**DOWNTOWN PLAZA & BANDSTAND
500 Main Plaza
New Braunfels, TX 78130**

ADA SELF-EVALUATION FACILITY SURVEY

New Braunfels Downtown Plaza & Bandstand

#8 Priority 1: Accessible Routes

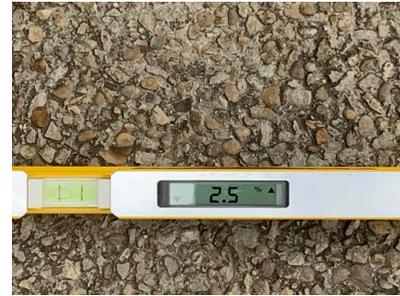
The sidewalk around the bandstand has cross slopes ranging from 2.5% to 5.8% and openings greater than 1/2".

Recommendation: Remove and replace sidewalk. (480 SF)

#13 Priority 1: Accessible Routes

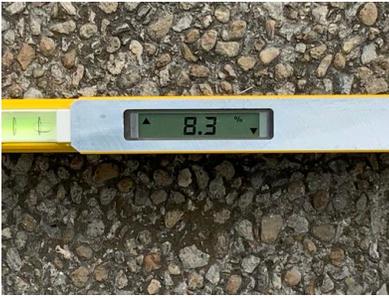
The sidewalk from the north perimeter sidewalk has a running slope of up to 8.3% and changes in level in excess of 1/2".

Recommendation: Remove and replace sidewalk. (75 SF)

#14 Priority 1: Accessible Routes

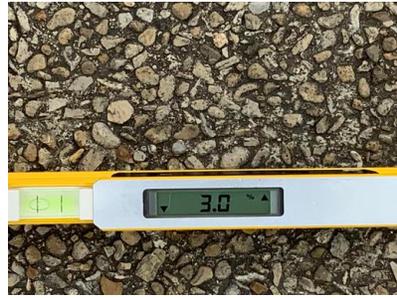
The sidewalk around the memorial has cross slopes ranging from 2.5% to 3.5% and excessive gaps and changes in level.

Recommendation: Remove and replace sidewalk. (660 SF)

#15 Priority 2: Protruding Objects

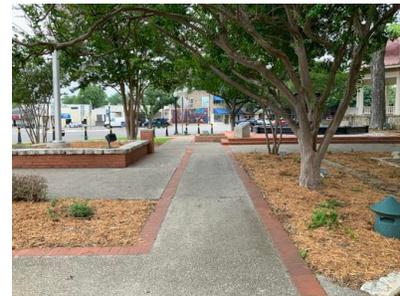
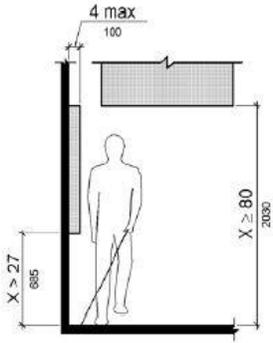
The north side of the sidewalk around the memorial has low tree branches with an overhead clearance of only 70".

Recommendation: Trim tree branches.

#17 Priority 2: Protruding Objects

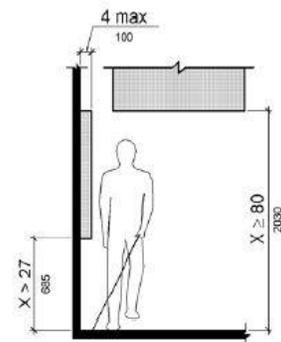
Description
The route from the perimeter sidewalk to the back of the bandstand has low tree branches with an overhead clearance of only 74".

Recommendation: Trim tree branches.
